Five-Year Review Report

Second Five-Year Review Report for Zanesville Well Field Site City of Zanesville **Muskingum County, Ohio**

September 2006

PREPARED BY: United States Environmental Protection Agency Region 5 Chicago, Illinois

Figure 1. City Well W-12. Pump is located on top of platform.

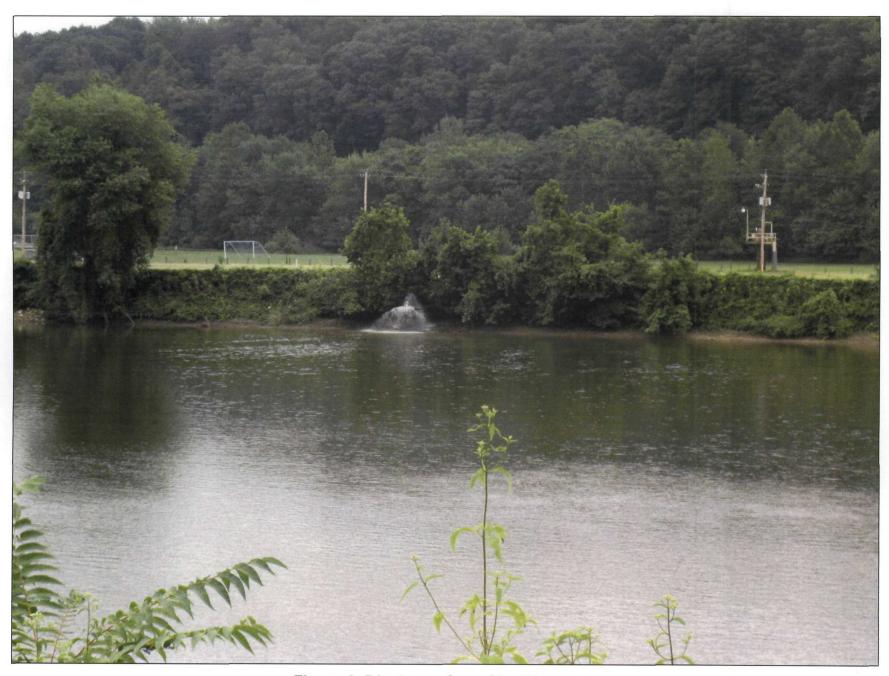
Two access issues were identified as a result of the site inspection. Access to the ZMWF wells is unrestricted because it is a park. Park goers can easily gain access to the pumps via ladders affixed to the platforms which the pumps sit upon (see Figure 1 located in Attachment 5). Interference to the remedy is possible, though unlikely, and discussions are taking place to address this issue. Secondly, the Ohio Department of Natural Resources (ODNR) installed a boat ramp at the entrance to the ZMWF. Boaters who travel a short distance upstream would have access to the outfalls where UTA discharges treated and untreated groundwater being pumped as part of the remedy (see Figure 2 located in Attachment 5). Discussions are also underway to restrict access to outfalls.

- b. An IC Action Plan will be completed by EPA
- 5. Access Issues
 - a. Steps will be taken in order to prevent direct contact with discharge points
 - b. Steps will be taken in order to prevent interference with well pumps W-6 and W-12
